PLAN ENDORSED FOR IN-PRINCIPLE APPROVAL

Rev. I	01 Sep 2021	For publishing on IPA website	ANJ	NFC	NFC
No:	Date	Description	Drawn	Checked	Approved
ASTDS		40T BOLLARD PULL ASD TUG			
DESIGN NO : CT3240		TITLE	SINGLE LINE DIAGRAM		
COCHIN SHIPYARD LIMITED P.O. Bag 1653, COCHIN-682015, INDIA		NTS	A4	CT3240	CT3240-870-001
		Scale	Format	Project No.	Dwg. no.

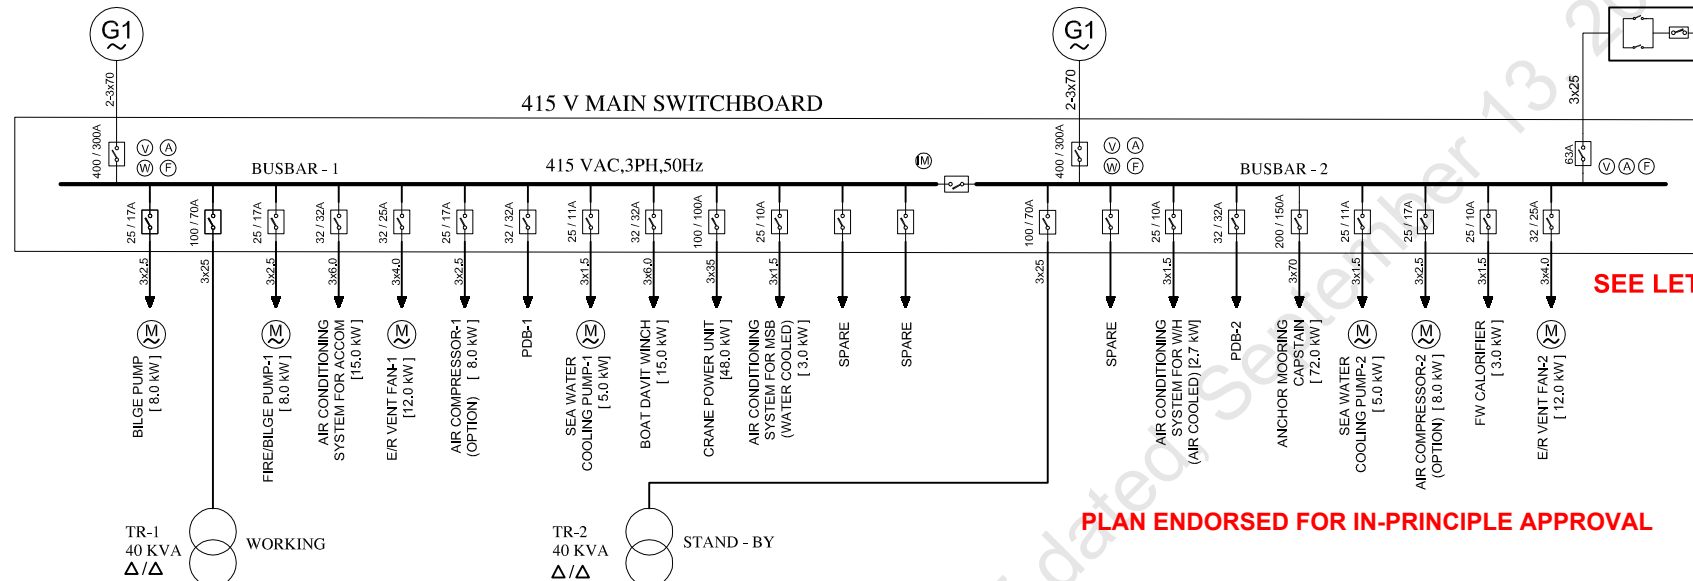
SWITCHING & PROTECTION COMPONENTS ARE TO BE OF APPROVED MAKE &TYPE

CABLES TO CONFORM TO IRS MAIN RULES
